Canadian Natural Upgrading Limited

Application for Muskeg River Mine Tailings Management Plan

Decision 20180523A: Canadian Natural Upgrading Limited; Application for Muskeg River
Mine Tailings Management Plan

Figure 1. New fluid tailings profile

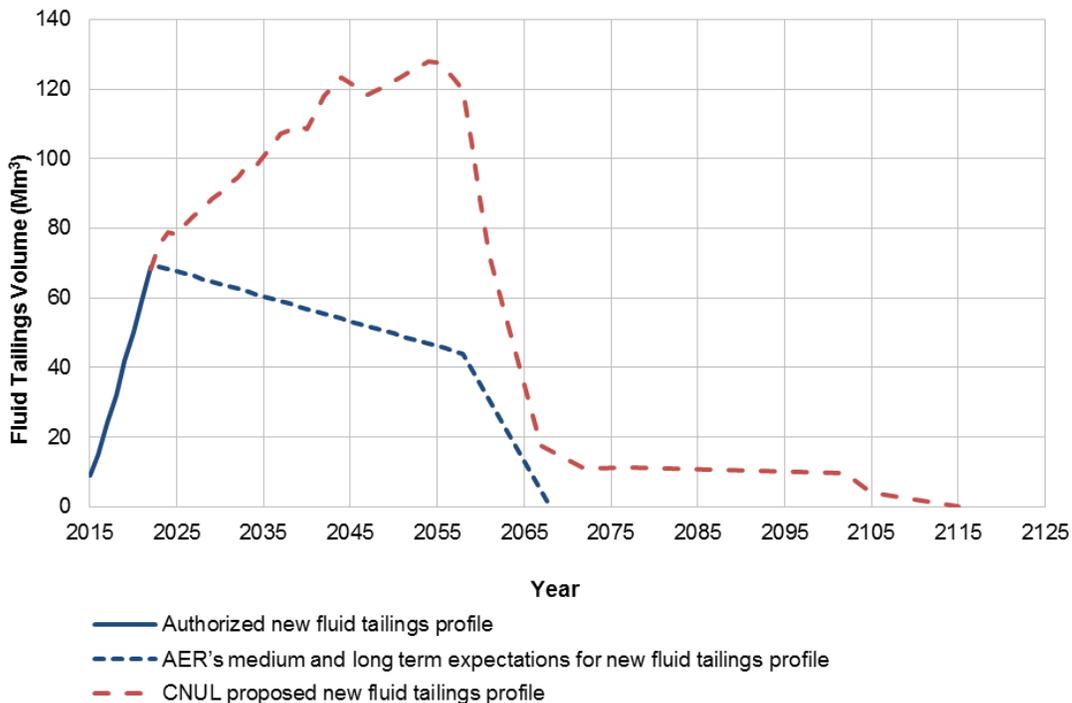
[30] However, CNUL's proposed new fluid tailings profile beyond 2022 does not meet the *TMF*'s objective or the *TMF* and *Directive 085* profile guidance for the following reasons:

[33] At a minimum, the AER expects CNUL's amendment application to meet the new fluid tailings profile depicted in the dotted line in figure 1.

[32] To address the concerns, in the amendment application CNUL is required to provide a revised new fluid tailings profile that

Figure 2. Legacy fluid tailings profile

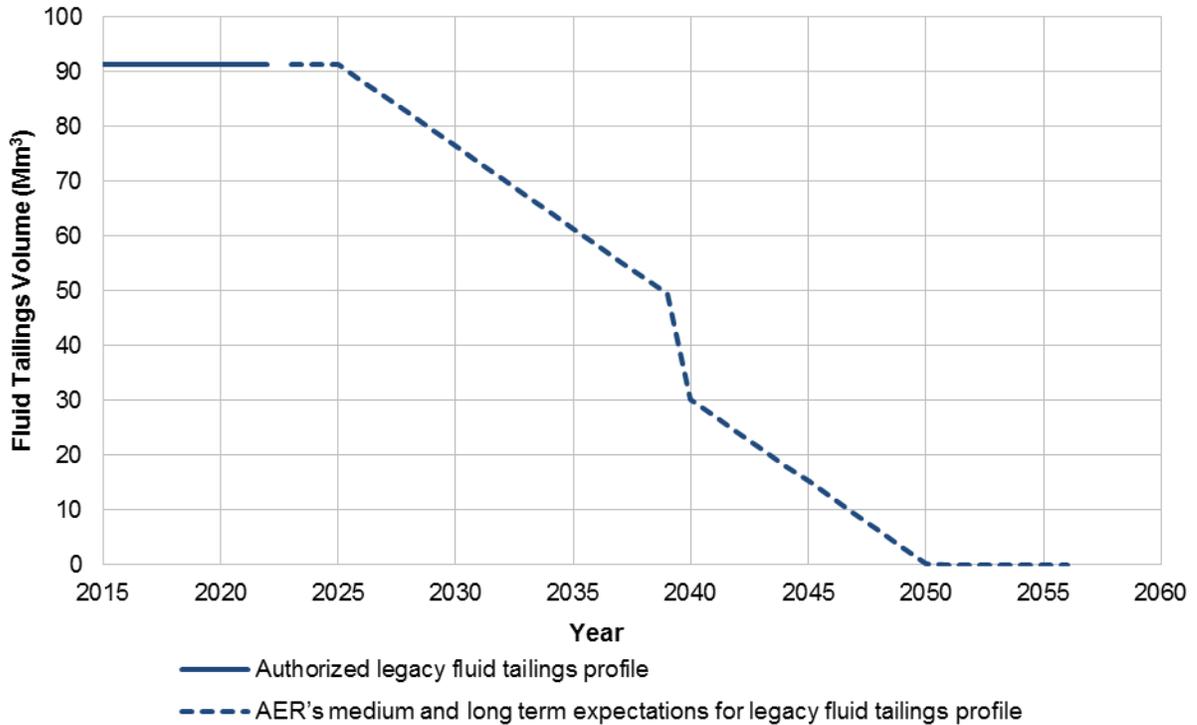
[37] CNUL's legacy fluid tailings profile meets the *TMF*'s objective because the existing volume of 91.4 Mm³ will be treated and will achieve RTR status by 2050, eight years before the end of mine life. However, the uncertainties over the medium and long term associated with technology implementation, the RTR criteria, and the revision of the new fluid tailings profile could impact the legacy fluid tailings profile. Consequently, CNUL's legacy fluid tailings profile is authorized until December 31, 2022, as shown in appendix B of the approval (appendix 1). The solid line in figure 2 depicts the authorized legacy fluid tailings profile that CNUL must achieve until December 31, 2022. The dotted line in figure 2 depicts CNUL's commitment to achieve RTR status for all legacy fluid tailings eight years before the end of mine life. The AER expects the legacy fluid tailings profile in CNUL's amendment application will meet or exceed this commitment.

[39] The AER expects the legacy fluid tailings profile in CNUL’s amendment application will meet or exceed its commitment that all legacy fluid tailings generated at the MRM are RTR by eight years before the end of mine life. At a minimum, the AER expects CNUL’s amendment application to meet the legacy fluid tailings profile depicted in the dotted line in figure 2.

[38] Further, CNUL is required to submit a revised legacy fluid tailings profile in the amendment application that
